Z-3
(2015)

PETITION NO: Z-3

Z-3

ZONING COMMENTS:

C-1.2

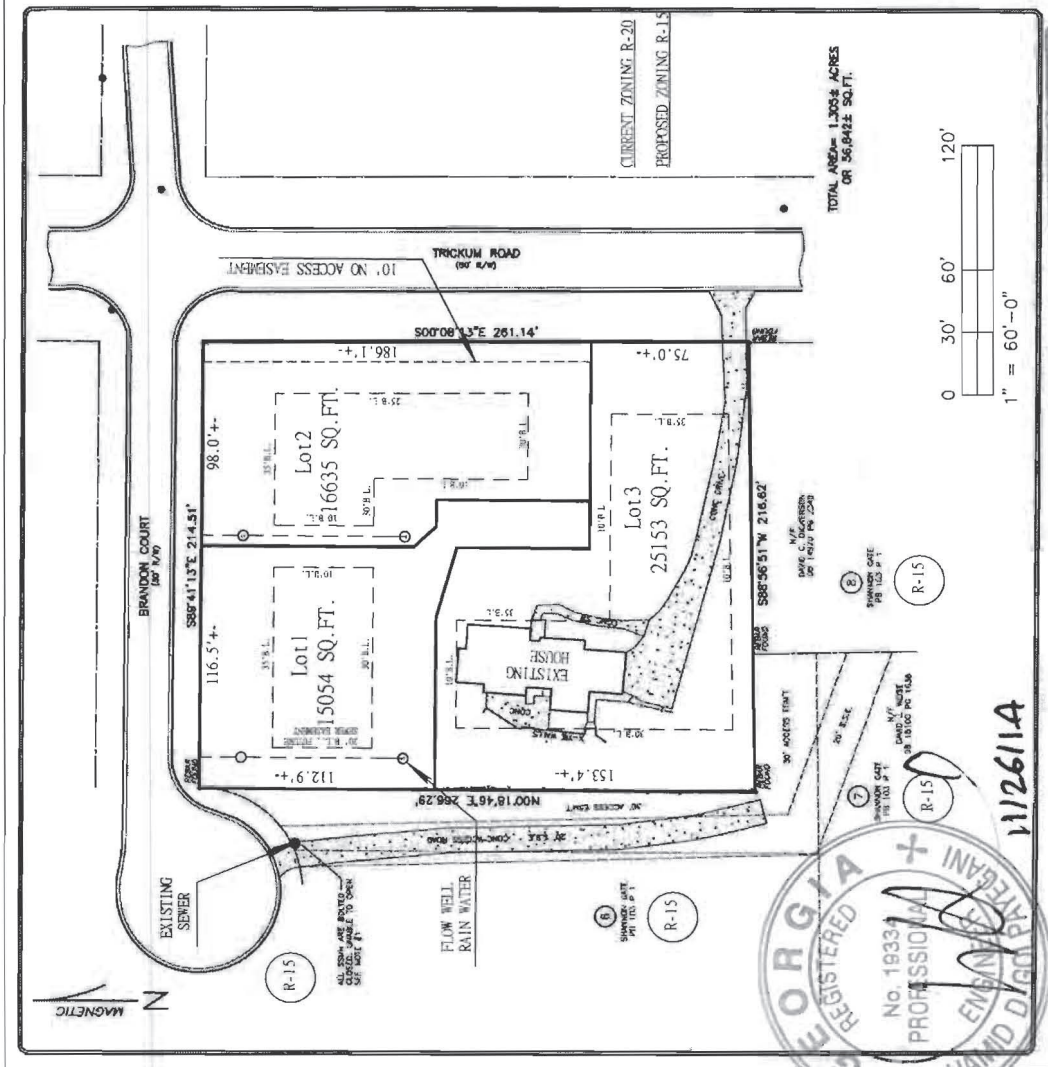
1. Dry wells will be required to meet water quality requirements for the new lots. Discharge pop-ups must discharge to the Brandon Court R/W. Lot plan permitting will require Stormwater Management approval of dry well design.

Recommend driveway access be limited to Brandon Court.

Recommend curb, gutter, and sidewalk along the Trickum Road frontage.

- Site plan received by Zoning Division on December 1, 2014;
- Stormwater Management Division comments and recommendations;
- Fire Department comments and recommendations; and
- Department of Transportation comments and recommendations.
